SI-HL-AE-890

South Texas Project
Units 1 & 2
Docket Nos. STN 50-498, STN 50-499
Geotechnical Engineering Information

On July 22, 1982, members of my staff met with Messrs. L. Heller and D. Gupta of the NRC Hydrological and Geotechnical Engineering Branch and Mr. D. Sells of your staff to discuss the licensing review of the South Texas Project geotechnical design. Attached is the geotechnical information on Essential Cooling Water (ECW) Pipeline soil profiles, the boundaries of the four low density backfill areas, contaminated backfill, settlement and nonconforming backfill beneath the ECW intake and discharge that was requested by the NRC staff during the above meeting.

SOUTH TEXAS PROJECT UNITS 1 & 2 POWER STATION PLAN ECM PIPELINE BORING PLAN Figure 1-4

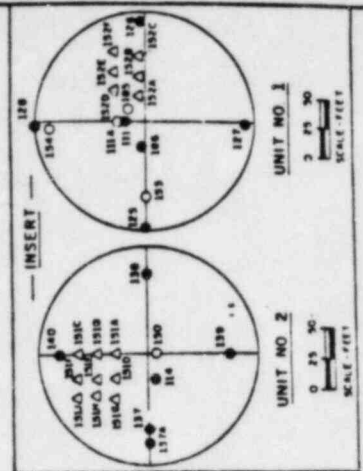
HL&P was requested to provide the following information related to the Essential Cooling Water (ECW) pipeline soil profiles:

- a) The South Texas Project (STP) position on the boring spacing requirements of Regulatory Guide 1.132,
- b) An evaluation of the Standard Penetration Test (SPT) results with blow counts less than 10 (N values) in the subgrade below the ECW pipeline, and
- c) A drawing depicting the location of the borings identified in ST-HL-AE-855 relative to the ECW pipeline.

As stated, the subsurface conditions are uniform (not variable); therefore, one boring per 100 linear feet would not be the requirement and a greater spacing is permitted. A lesser frequency of borings, as defined in Regulatory Guide 1.132 for uniform conditions, would accordingly be appropriate. Note that in addition to the borings obtained a continuous geologic mapping trench was excavated between Unit 1 and the Essential Cooling Pond, approximately following the ECWS piping alignment (PSAR Figure 2.5.1-45, attached).

The ECW Pipeline Boring Plan is shown in Figure 1-4.

FIGURE 2-1

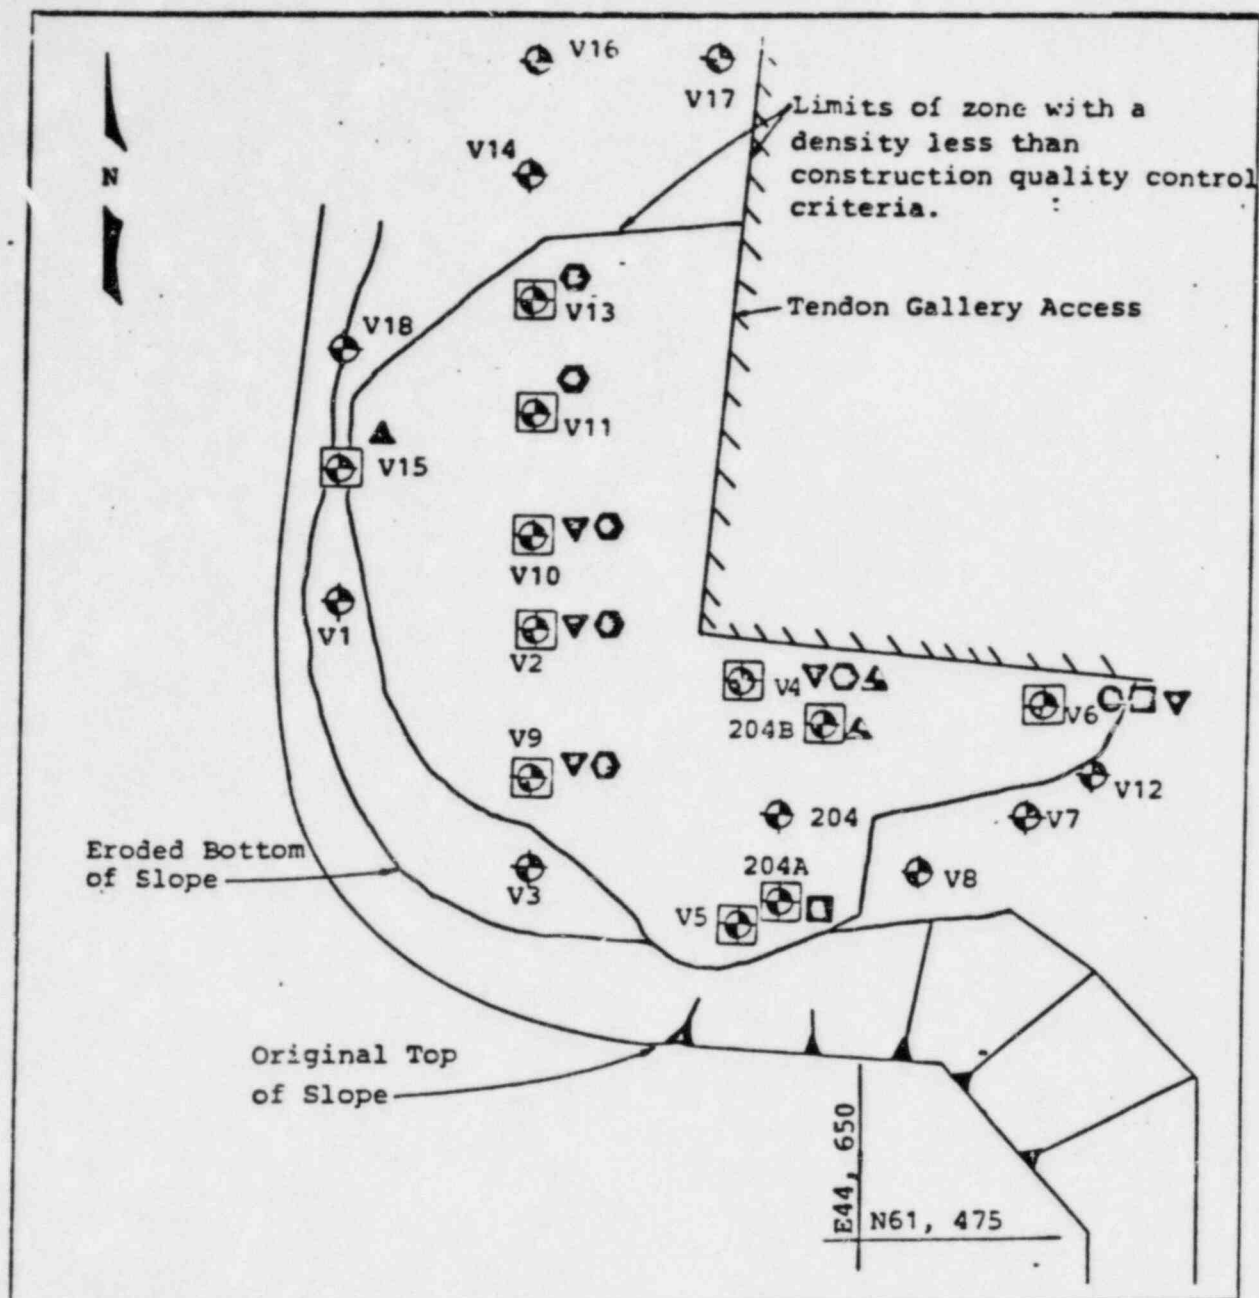
NRC requested that HL&P provide a discussion of the actual backfill construction sequence to explain how the boundaries of the four identified low density areas were established.

The fifteen original boring locations (part of Phase I) are shown on Figure 2-1. These borings were designated as 101 through 106 (Unit 1), and 201 through 209 (Unit 2). To gain additional information or samples, other borings were drilled for both phases in the vicinity of those shown. They were given the same base numbers, but with various suffixes (e.g., 205A, 205B, 205-V1, etc).

Four small areas within the Unit 2 area have relative densities (based on the Gibbs and Holtz correlation) less than the construction quality control criteria. The relative locations of these areas are generally situated as follows (refer to Figure 2-1):

UNIT 1
FIGURE 4-1

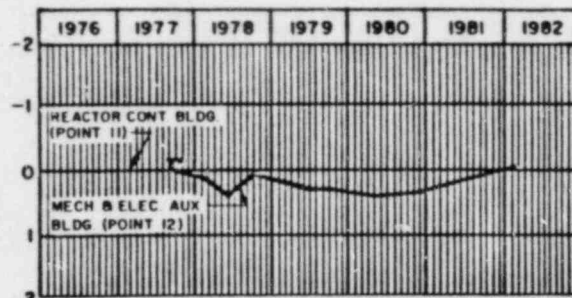
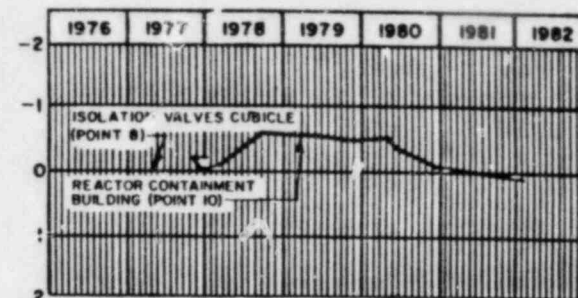
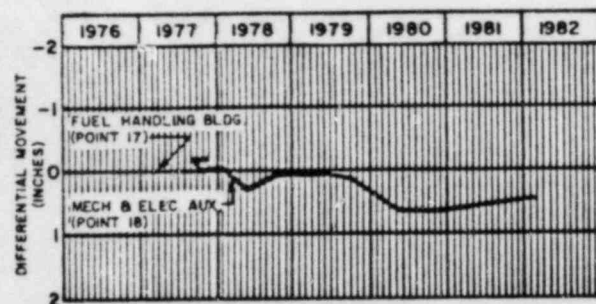
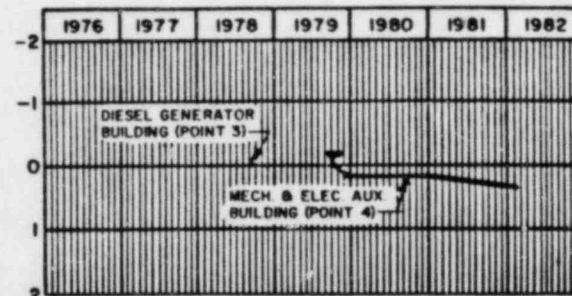
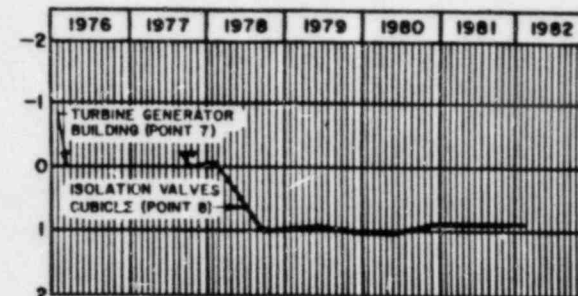
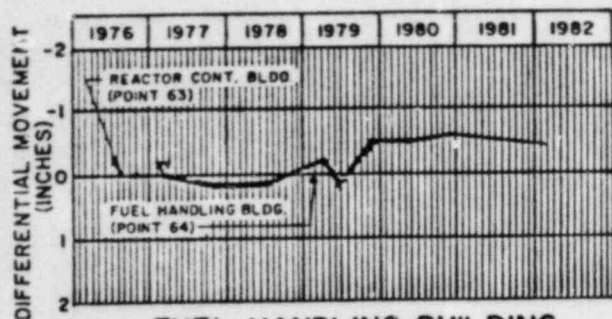
NRC requested that HL&P provide an evaluation of the observed settlement at STP to date.

The differential movements experienced between buildings are shown on Table 4-1 and Figure 4-1 and Figure 4-2 for Unit 1 and Unit 2, respectively. On these Figures six individual data graphs are shown. These graphs show differential movement of one point relative to another point. Figures 4-1 and 4-2 are updated through February 1982. To date, predicted and measured movements are good and within design criteria.
